Technical Service Bulletin

NUMBER: 09-06-00

Changes To Timing Belt Tensioner Components

This bulletin involves using new procedures when replacing/installing timing belt tensioner components.

**FIGURE 1**

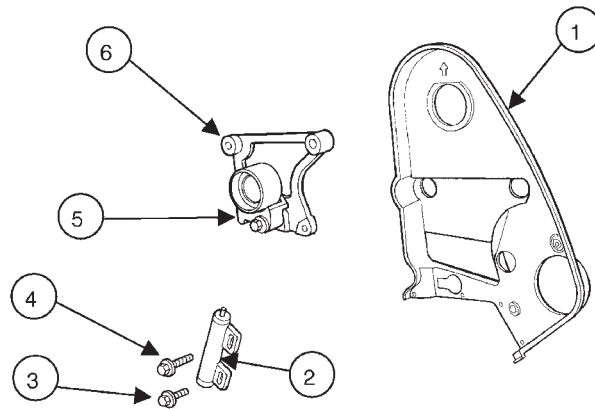
Each kit consists of a tensioner w/attaching bolts, tensioner pivot assembly, and rear timing belt cover (Figure 1).

3. Install a new rear cover and bracket assembly, from kit p/n 5018399AA 1999 Models w/o dowel locator or p/n 5018400AA 2000 Models w dowel locator (Figure 1). Torque all applicable bolts to the specifications listed in the service manual.

NOTE: THE BRACKET ASSEMBLY WITH THE SLEEVED LOCATOR HOLE SHOULD ONLY BE USED IF THE DISCARDED MECHANICAL TENSIONER HAD A SLEEVED LOCATOR HOLE.

FIGURE 2

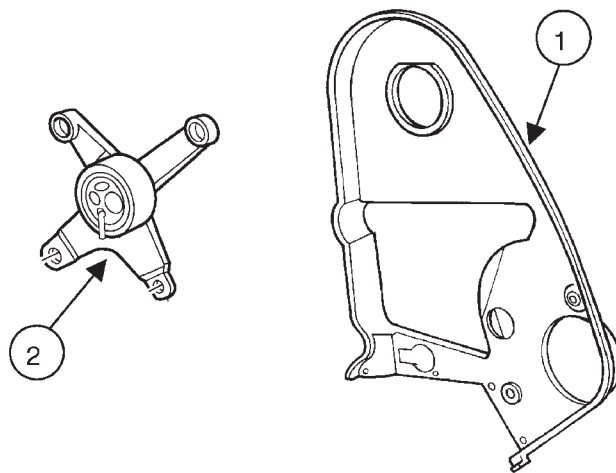
2. Remove and discard the mechanical timing belt tensioner assembly and rear-timing belt cover (Figure 2). Save the bolts that were used to mount the mechanical tensioner to the engine.

**FIGURE 3**

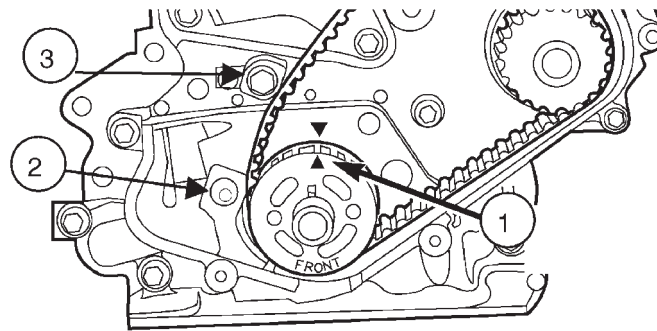
4. Follow the timing procedures (if required) in the service manual up to the point of rotating the crankshaft sprocket to TDC to take up slack in the belt.
5. To install the hydraulic tensioner, first remove and discard the upper bolt as shown in Figure 3. Install the hydraulic tensioner with the 2 bolts from the kit into the location shown in Figure 3. Do not tighten the 2 bolts at this time.

**FIGURE 4**

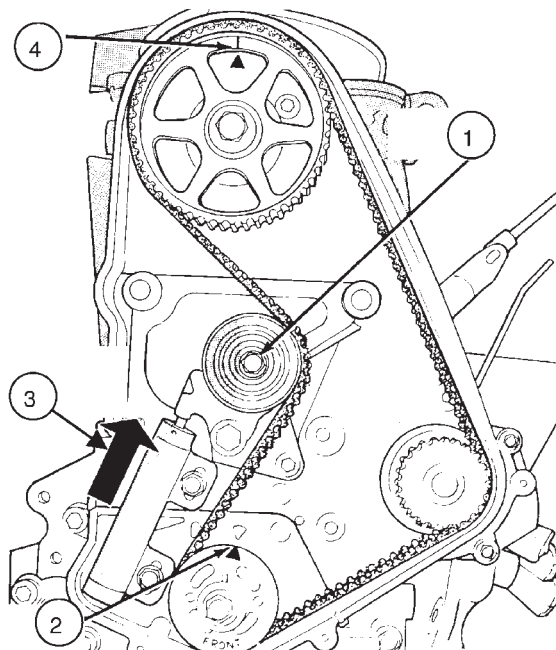
6. Using a torque wrench on the bracket assembly pulley (Figure 4), apply 28 Nm (250 in lbs) of torque against the timing belt.

7. While torque is being applied to the pulley/belt, move the tensioner up against the bracket assembly and tighten the 2 bolts to 31 Nm (275 in lbs).
